NUREG-1125
Volume 21

A Compilation of
Reports of
The Advisory
Committee on
Reactor
Safeguards

1999 Annual

U. S. Nuclear Regulatory
Commission

Figure 1. Possible implementation of the structural model at a high level.

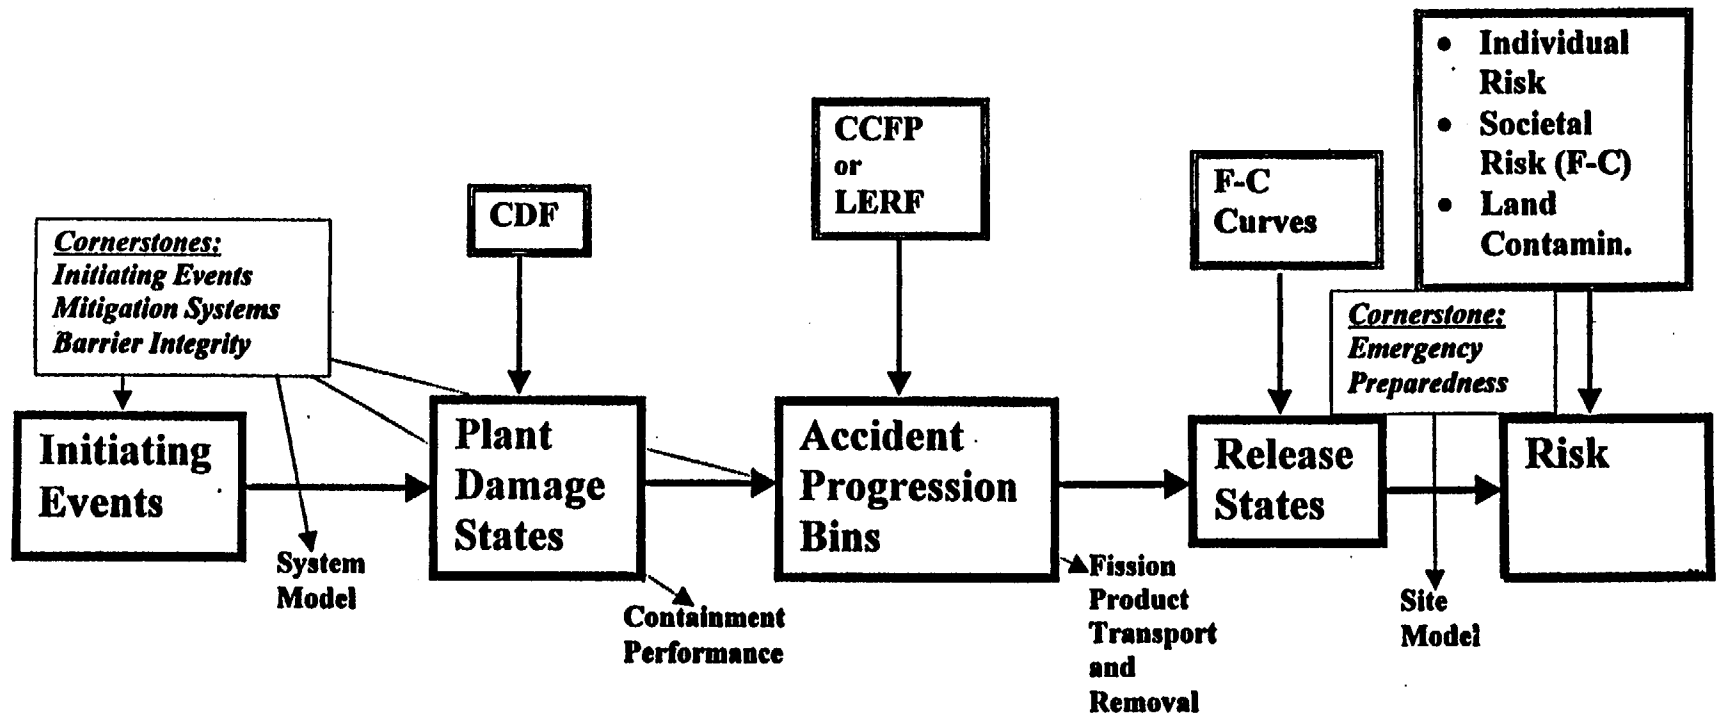
We note that our first example dealing with CDF and CCFP addresses the top level of Figure 1 of the attached paper. If one adopts the structuralist viewpoint at that level, as the paper's preliminary proposal suggests, then the tradeoffs of our example between CDF and CCFP will have to be performed under the assumption that at least some level of defense in depth will be required. If, on the other hand, one adopts the rationalist view even at that level, it is conceivable that the LERF objectives could be satisfied without a containment. Our second example dealing with fires exemplified the rationalist view at lower levels, as the preliminary proposal recommends.

The rationalist model would be applied at levels lower than the cornerstones of Figure 1. Defense in depth would be used only to address uncertainties in PRA at the lower levels, thus becoming an element of the overall safety analysis. For events or processes that are not modeled in PRA, defense in depth would play its traditional role. Such is the case with the impact of smoke from fires on plant safety. Current fire risk assessments do not account for the effects of smoke, therefore, prescriptive defense-in-depth based

Attachment: Figure

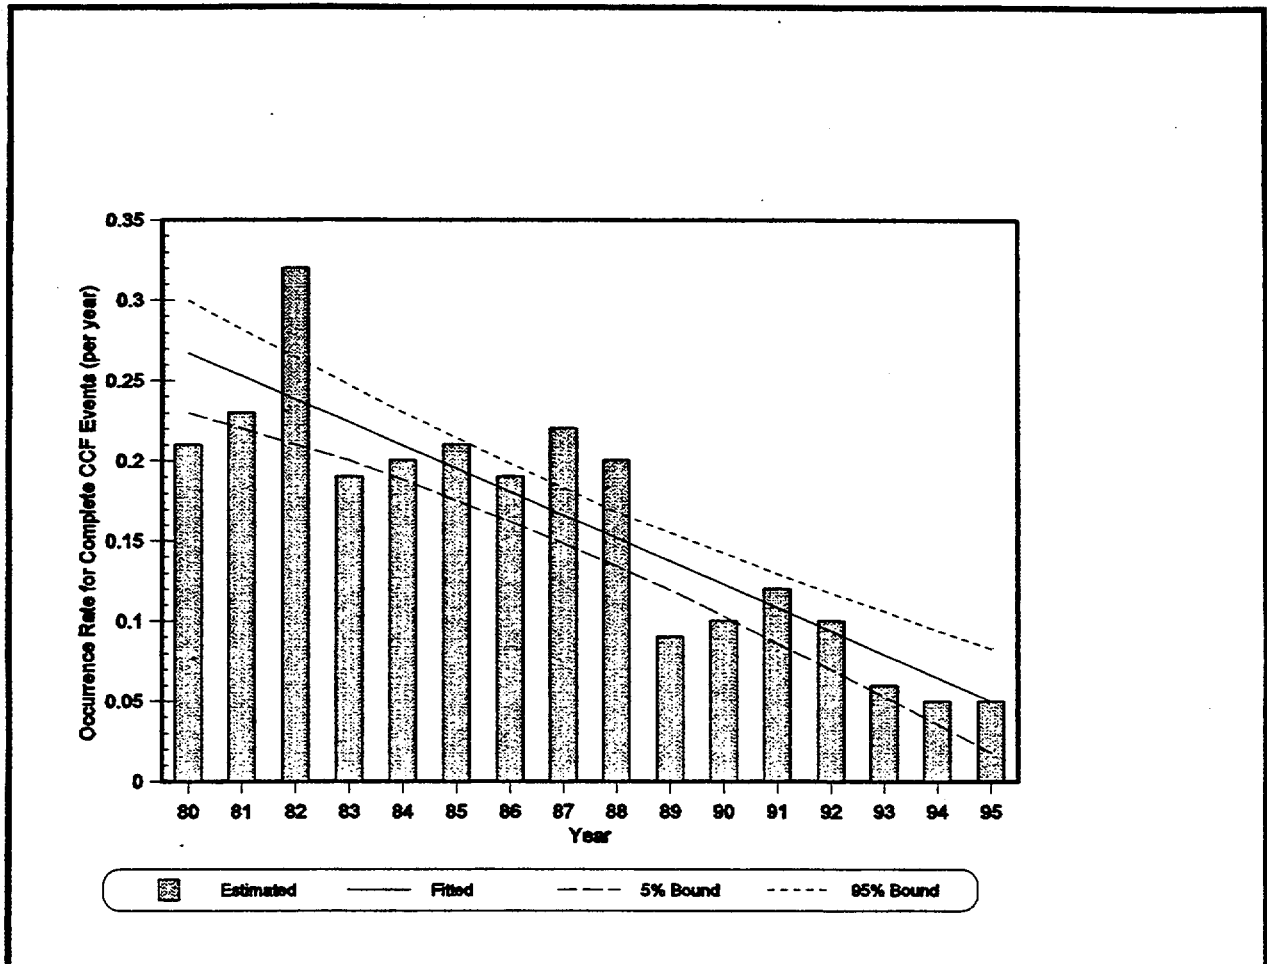
We are somewhat concerned that the staff does not plan to determine whether the licensees are implementing any actions based on the insights of NUREG/CR-6268 to reduce the potential for CCFs. However, given the general awareness of the CCF issue that we mentioned earlier, we do not believe that this is a sufficient reason to justify delaying the resolution of GSI-145. The staff should, of course, be vigilant to identify any signs that the downward trend in the CCF rate has reversed.
